# UNITED STATES PATENT AND TRADEMARK OFFICE

APPLICATION NO.	FILING DATE	FIRST NAMED INVENTOR	ATTORNEY DOCKET NO.	CONFIRMATION NO.
10/524,878	02/17/2005	Kurt Johannes Weschenfelder	W1.1882 PCT-US	5620

<b>Office Action Summary</b>	<b>Application No.</b>	<b>Applicant(s)</b>	
	10/524,878	WESCHENFELDER ET AL.	
	<b>Examiner</b>	<b>Art Unit</b>	
	Leslie J. Evanisko	2854

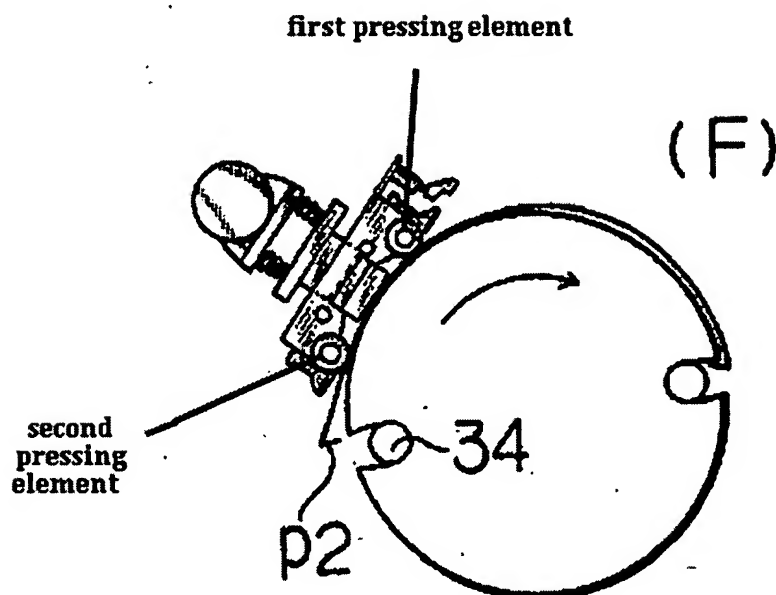
9. Claims 70-72 are rejected under 35 U.S.C. 102(b) as being anticipated by Suzuki et al. (US 4,727,807). Suzuki et al. teach a method for pressing a dressing P on a cylinder A of a printing press comprising: providing at least one first pressing element positioned adjacent a surface of the cylinder, providing at least one second pressing element positioned adjacent the surface of the cylinder, spacing the first and second pressing elements apart from each other in a circumferential direction of the cylinder with the first pressing element leading and the second pressing element trailing in a production direction of rotation of the cylinder, providing suspension legs P1, P2 beveled off at ends of the dressing, providing at least one axially extending, dressing suspension leg receiving opening a1 in the surface of the cylinder, inserting a leading one of the dressing suspension legs into the opening (Fig. 8(D)), rotating the cylinder in the production direction (Figs 8(E), 8(F)), and using the second pressing element for pressing a trailing one of the dressing suspension legs into the opening (Fig. 8(G)). Particular attention is invited to Figures 8(A)-8(G) of Suzuki et al. and specifically, the marked up copy of Figure 8(F) shown below.
